St. Lucie Units 1 and 2  
Docket Nos. 50-335 and 50-389

Florida Power & Light (FPL)/St. Lucie's Third Overall Integrated Plan Status Report in Response to March 12, 2012 Commission Order Modifying Licenses with Regard to Requirements for Mitigation Strategies for Beyond-Design-Basis External Events (Order Number EA-12-049)

Third Six Month Status Report for the Implementation of Order EA-12-049, Order Modifying Licenses with Regard to Requirements for Mitigation Strategies for Beyond-Design-Basis External Events

Figure 23 Connections for Secondary Water Sources (Ft. Pierce Utilities) for SFP FLEX Pump Suction and FLEX CST Pump Suctions (Rev. 0)

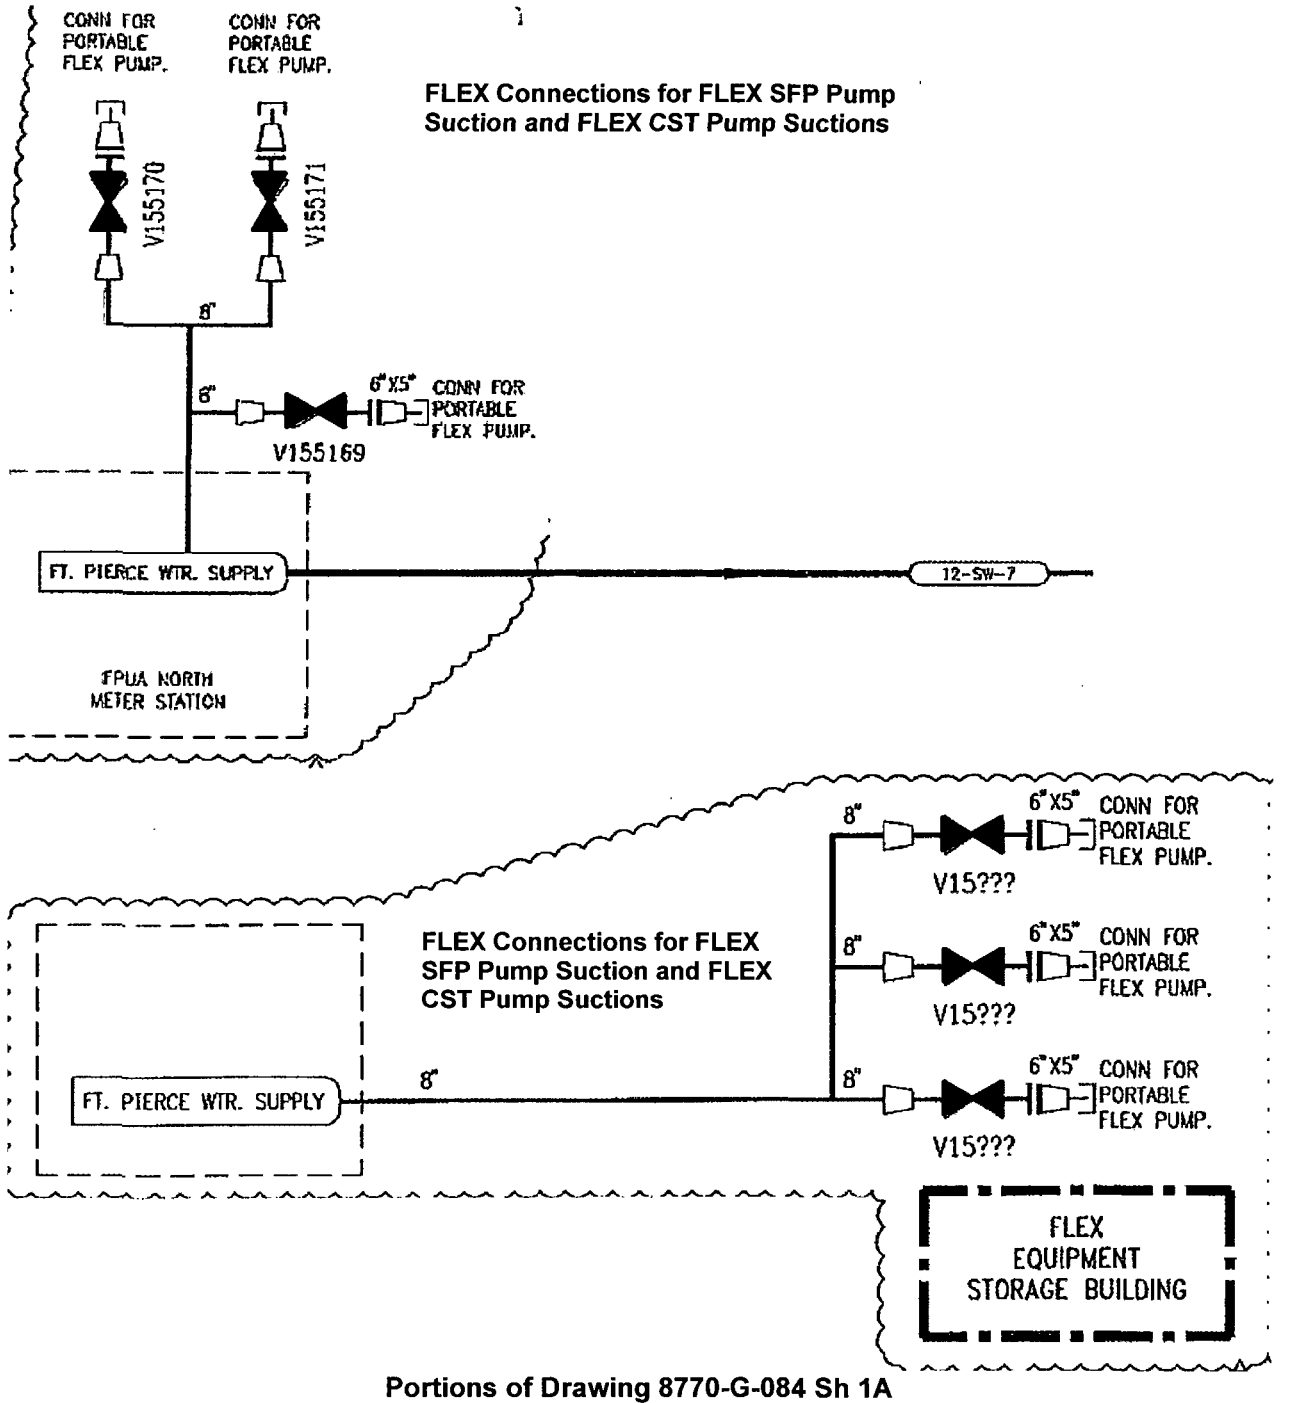
tanks will survive a high wind-tornado based event based on their design, separation and intervening structures; the CWSTs, TWST and/or PWSTs should be available as secondary sources of water to provide makeup to the CSTs/RWTs during Phase 2 following a high wind missile event. An alternate makeup water strategy credits the underground water supply line from Fort Pierce Utilities (FPU), the local potable water supplier. Rather than missile protecting the single existing source from tornado, a second source will be installed and separated by greater than diameter of typical tornado path (1200 ft) with that path oriented from the west to southwest. See new Figure 23.
